Change Order

Radcliff Elementary School Renovation
- Phase 3
1145 S. Dixie Boulevard
Radcliff, Kentucky 40160

CHANGE ORDER NUMBER: 001**DATE:** April 21, 2011**TO CONTRACTOR (Name and address):**

Work Changes Proposal Request

REVISED WILSON ROAD ENTRANCE

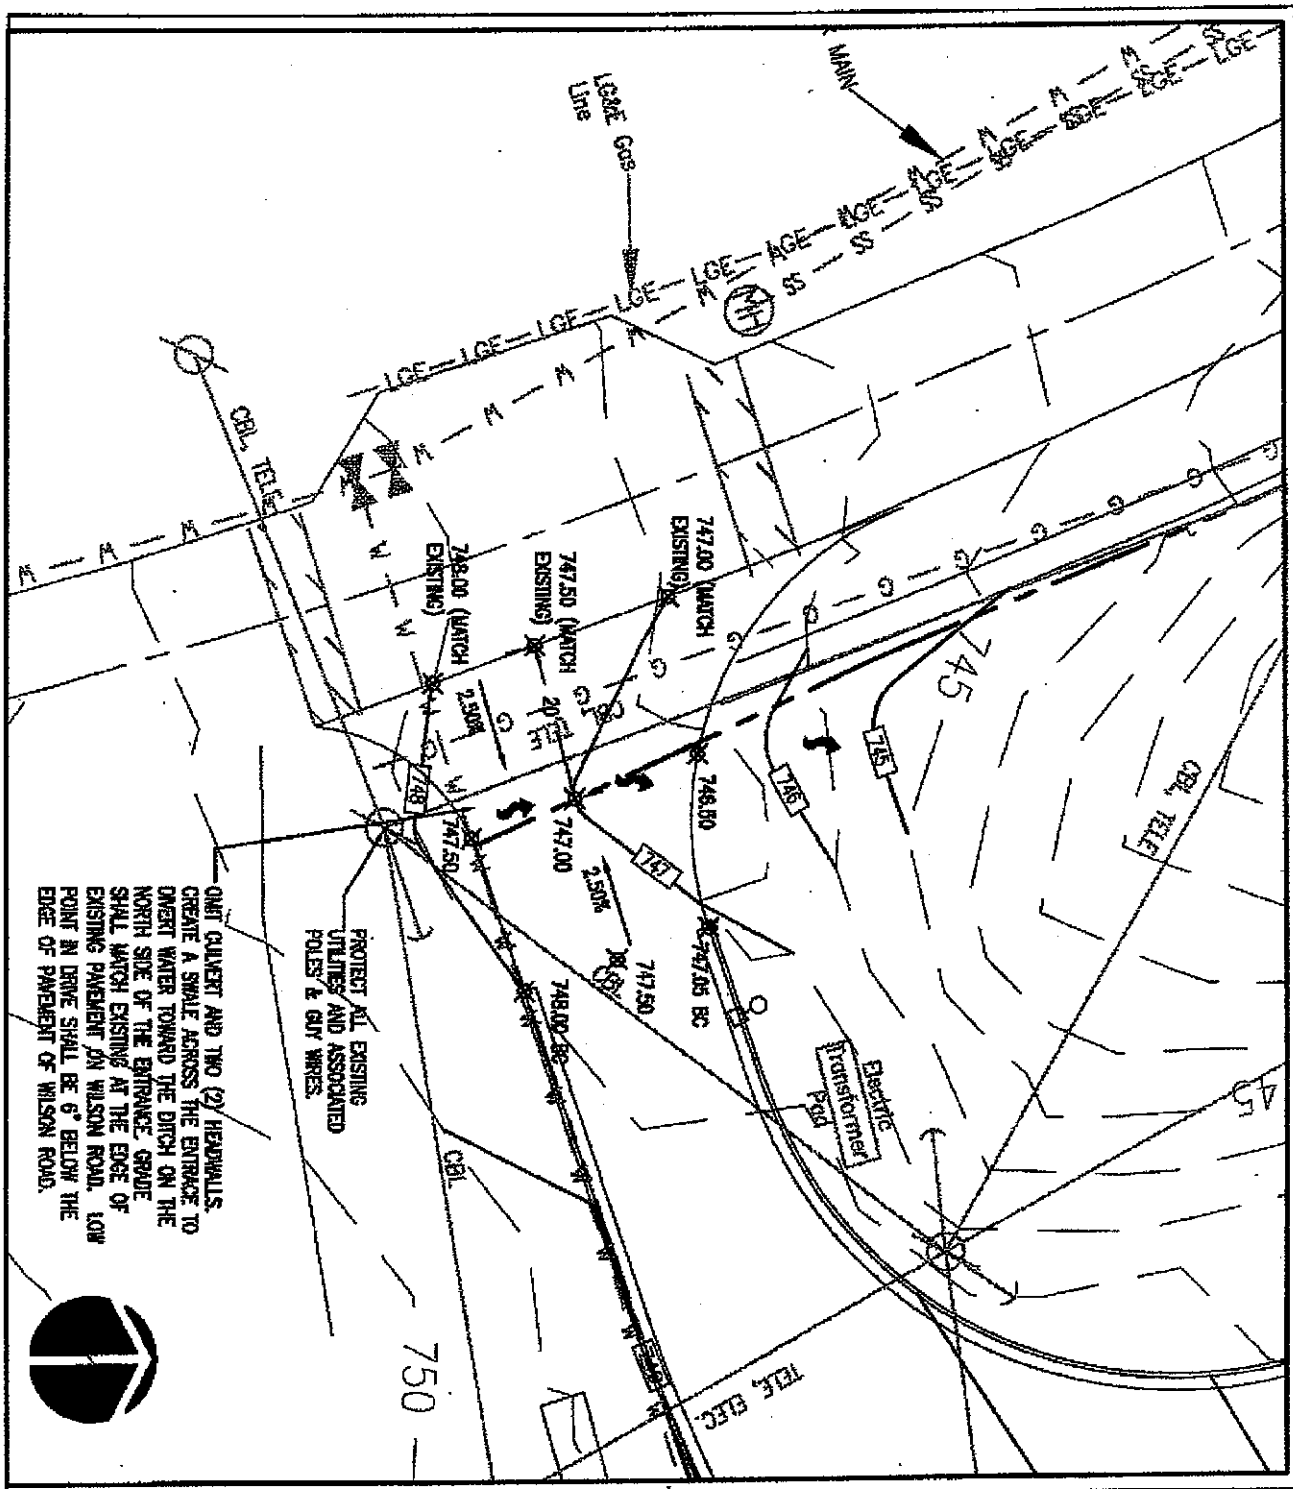
Contractor shall provide credit pricing to omit culvert pipe, two headwalls and all associated labor and materials and revise grades to create a shallow swale across the pavement to divert stormwater to the ditch on the north side of the entrance per the attached drawing.
